State Environmental Quality Review  
**Findings Statement**

**Name of Action:** Westwood Neighborhood

AMHERST TOWN BOARD  
FINDINGS STATEMENT  
ON WESTWOOD NEIGHBORHOOD REZONING APPLICATION  
December 11, 2017

### CONCEPTUAL MASTER PLAN

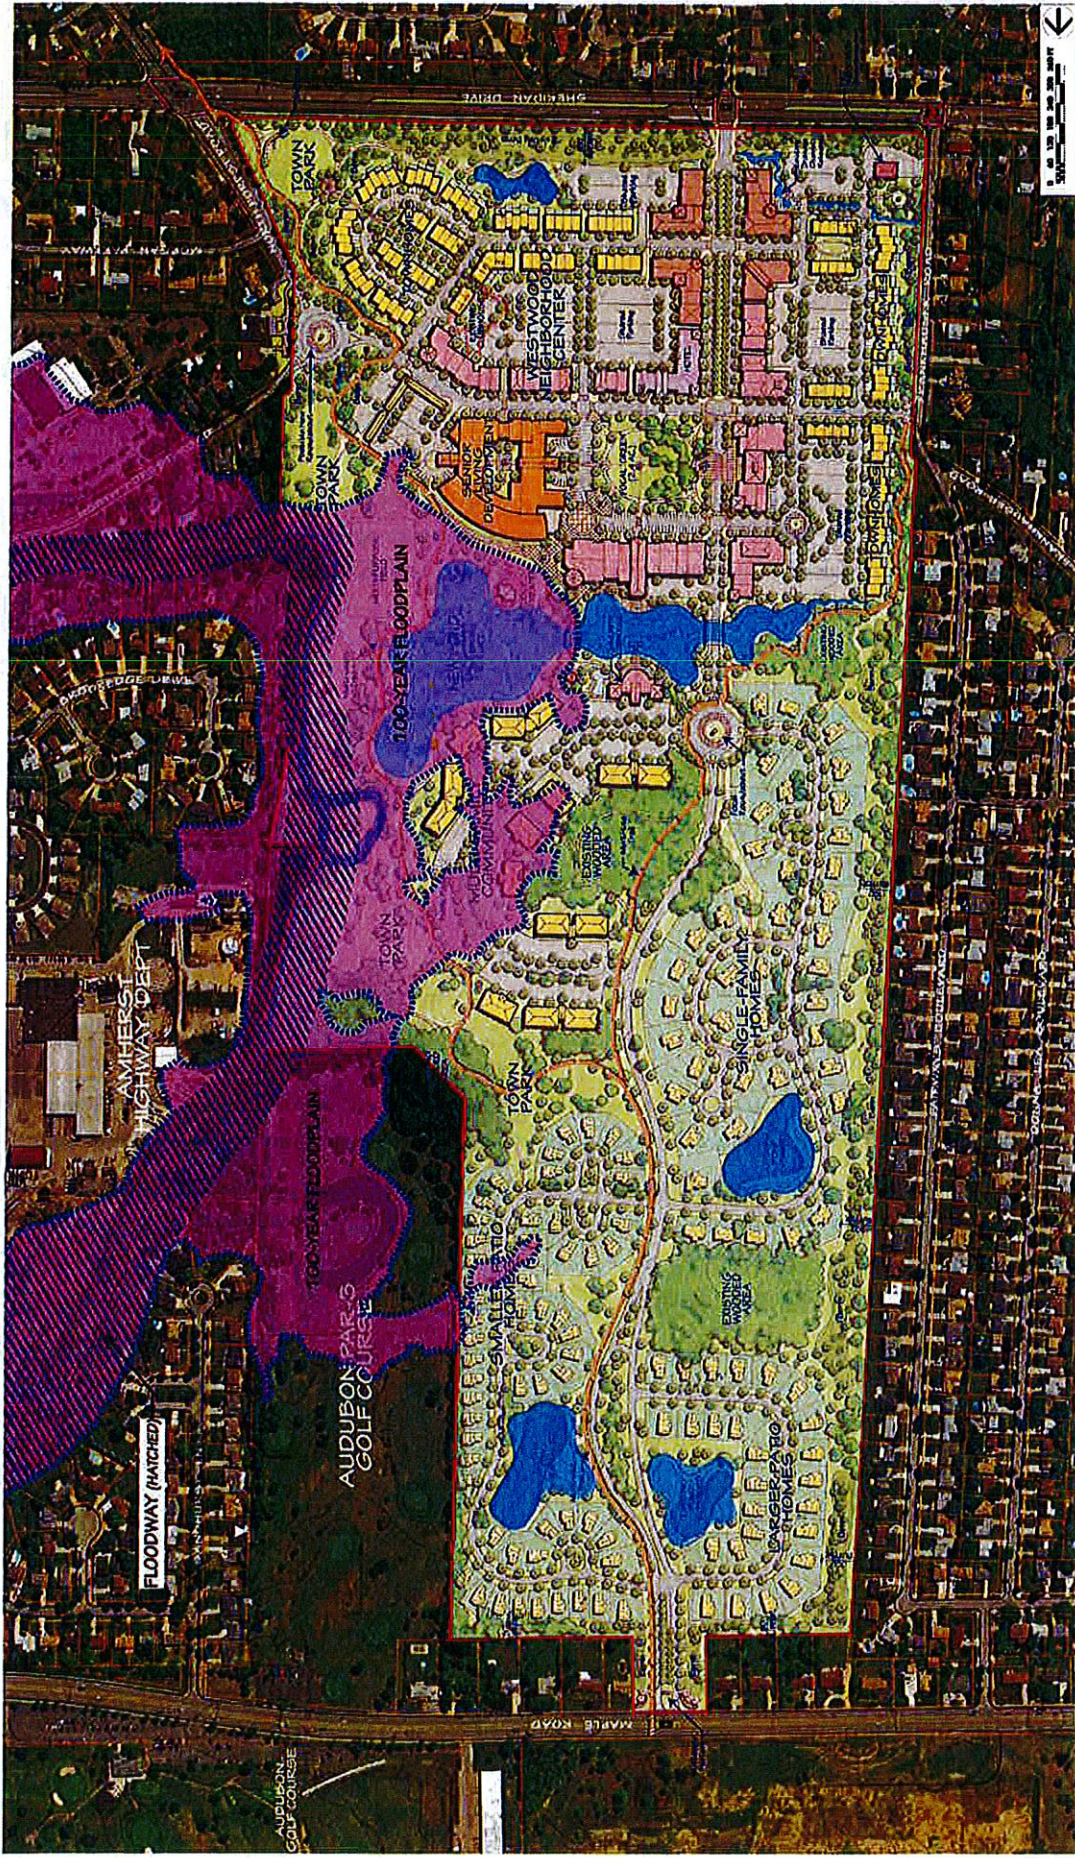
- b) As proposed, the overall Project is too dense for the surrounding neighborhoods and is not consistent with the adopted Bicentennial Comprehensive Plan in that the Property is not designated as a Mixed-Use Activity Center.

appropriate for the Property or consistent with surrounding development/zoning. Inserting a GB use in the midst of a TND development conflicts with the overall concept of the TND.

- e) Further, the current mix of uses, scale and density of the southern-most portion of the Project is not compatible with the character of the surrounding neighborhoods, which is a requirement of the TND. The office and commercial uses of the Project contrast with the previous golf course use and with the surrounding residential neighborhood.

- f) The Project meets some mixed-use objectives as described in the Comprehensive Plan, but the overall Project is too dense and incompatible with the surrounding neighborhoods.

- eliminates the hotel, which would remove the need for the GB district, which is inconsistent with the TND District concept;
  - is consistent with the available wet weather sanitary sewer capacity;
